NOTICE TO ALL BIDDERS

Re: GYM HVAC REPLACEMENT - BUILDING 700
RFP No 20-21-19
Addendum #2

Document Additions, Revisions and Clarifications

1 SINGLE LINE DIAGRAM - WEST (OUTDOOR EQUIPMENT YARD) RENOVATION
NO SCALE

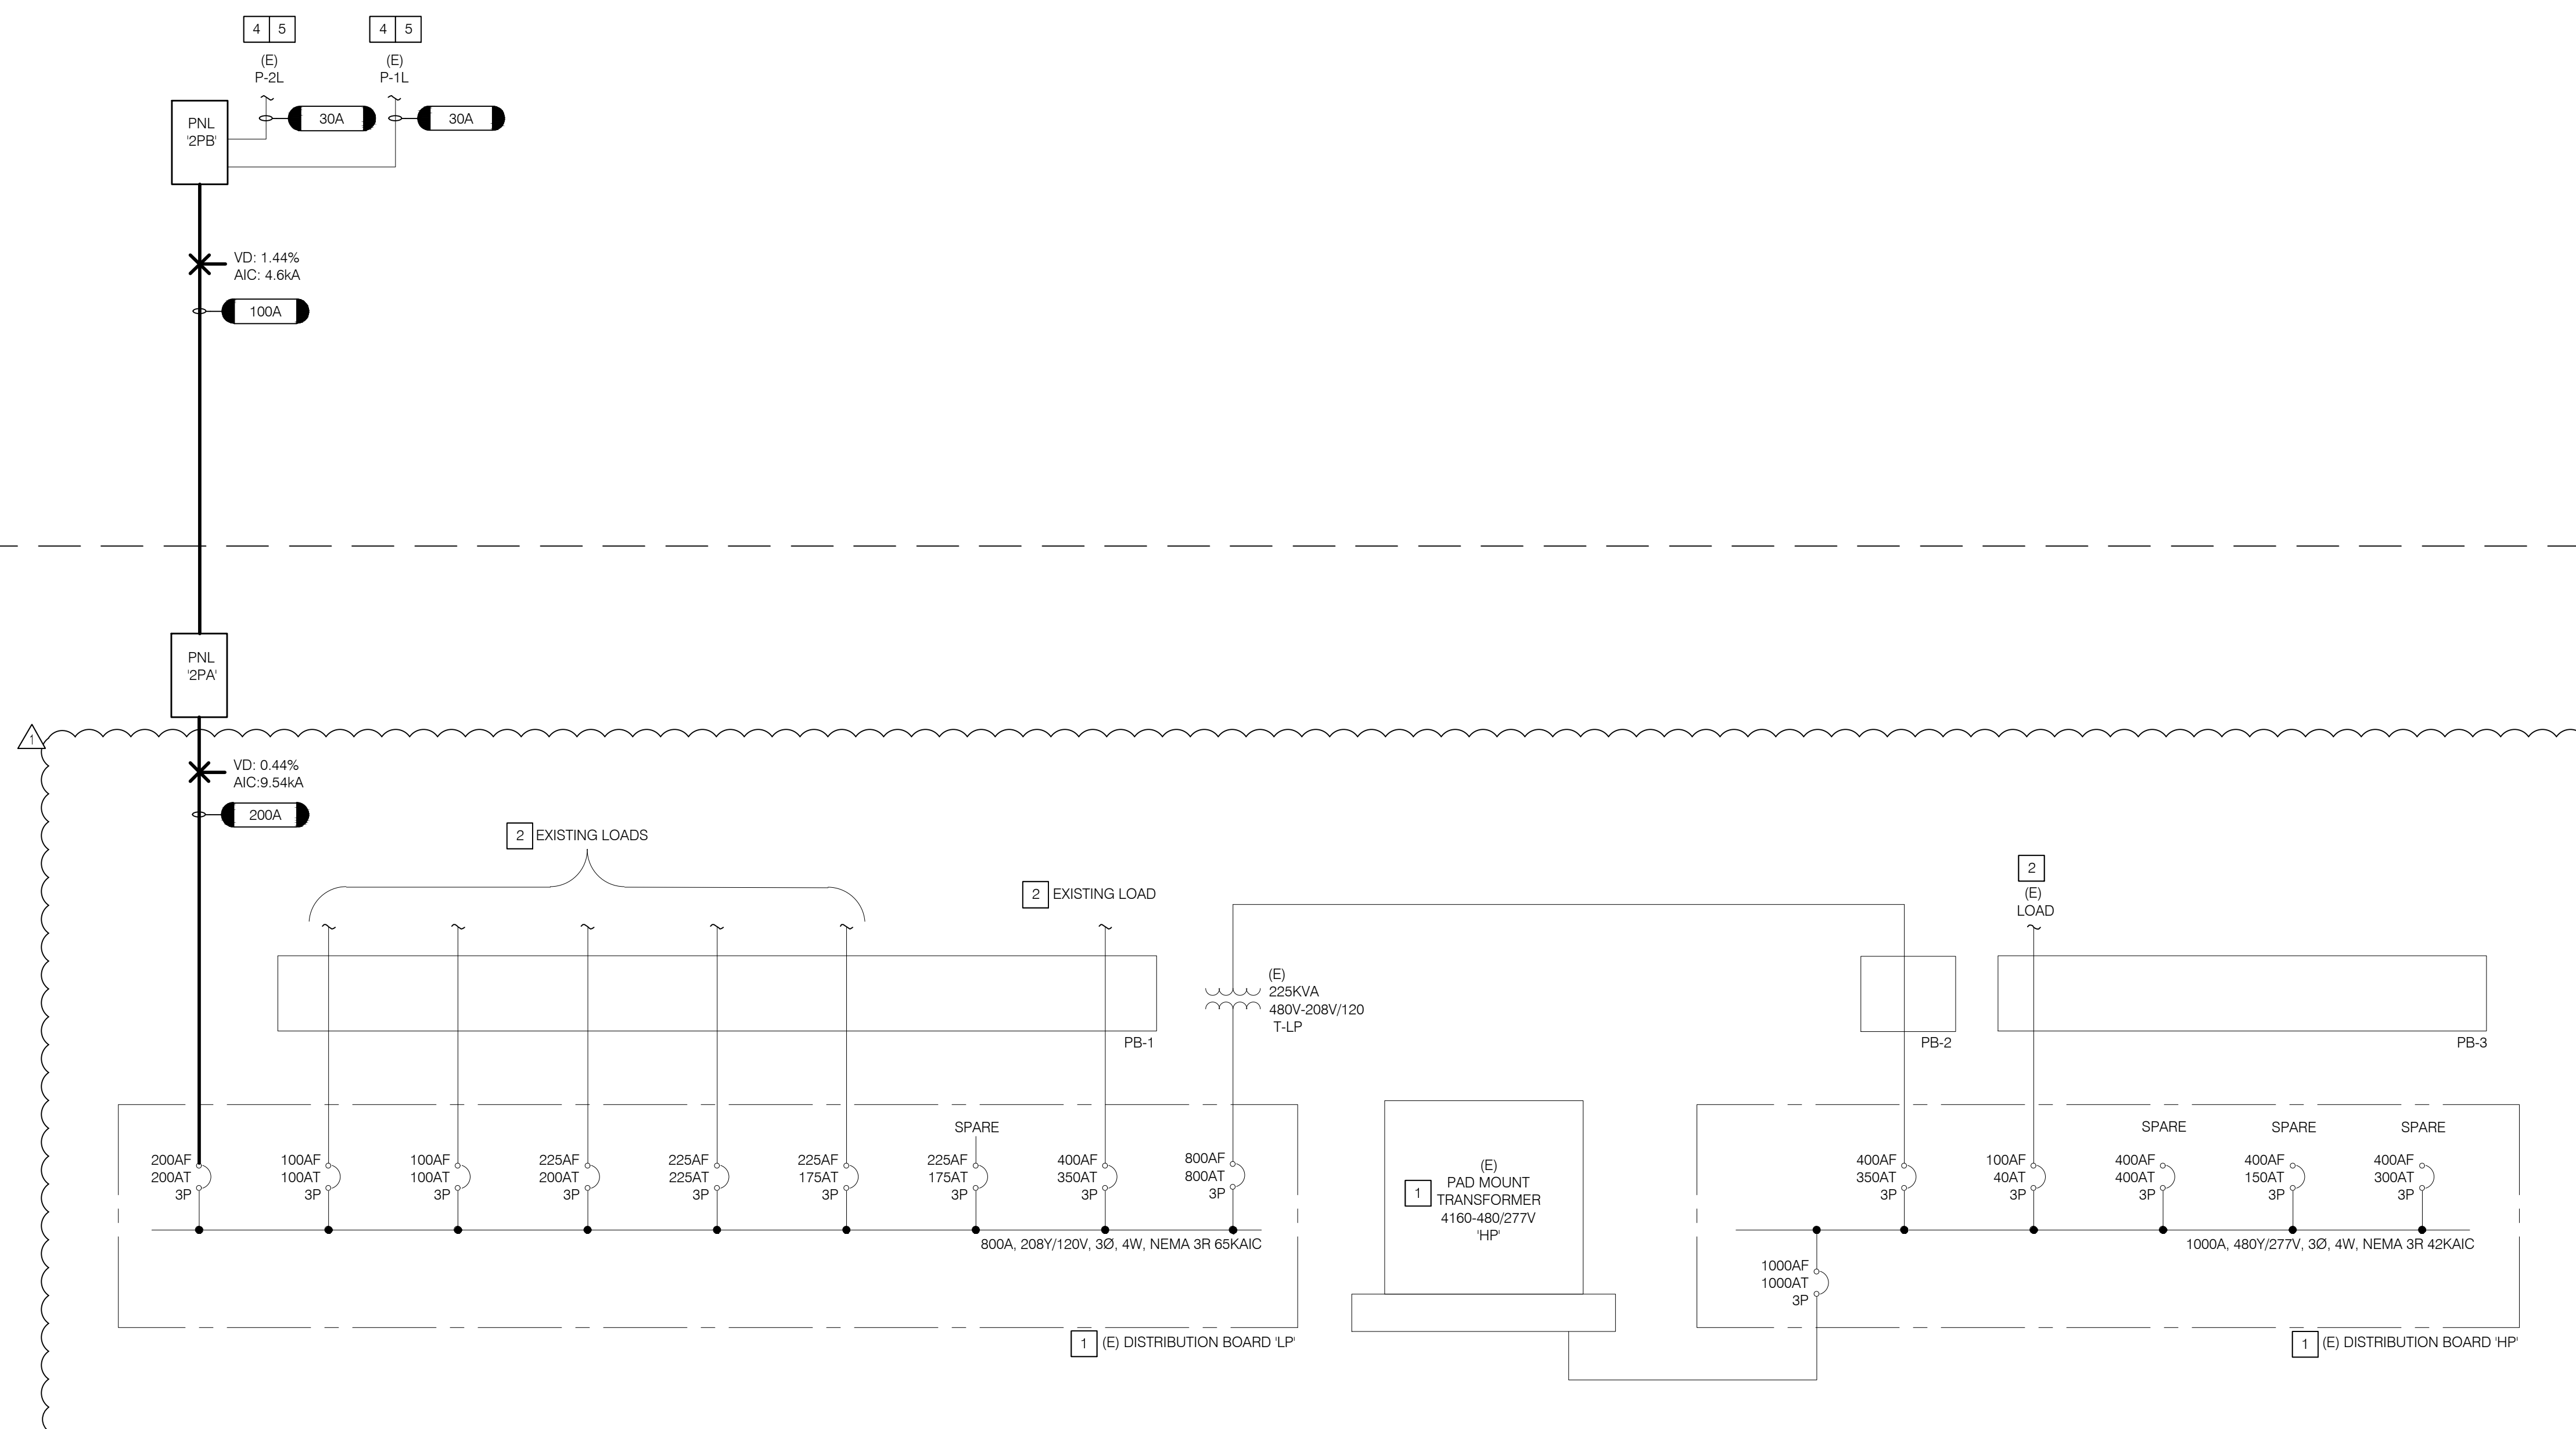
2. **Question:** According to prints, the exhaust fans located over locker room need to be replaced and piped to panel 2PB. According to maintenance personnel these fans are currently fed from switchboard 2DB. There are also several breakers in panel 2DB that are not being used. Do you still want the exhaust fans feed from panel 2PB or have them stay in their current switchboard?

Answer: For bidding purposes Contractor shall provide new conduit and wire and reconnect exhaust fans to panel 2PB per bid documents. Contractor may propose alternate panel, if electrical gear is in good working condition and is not a Zinsco model.
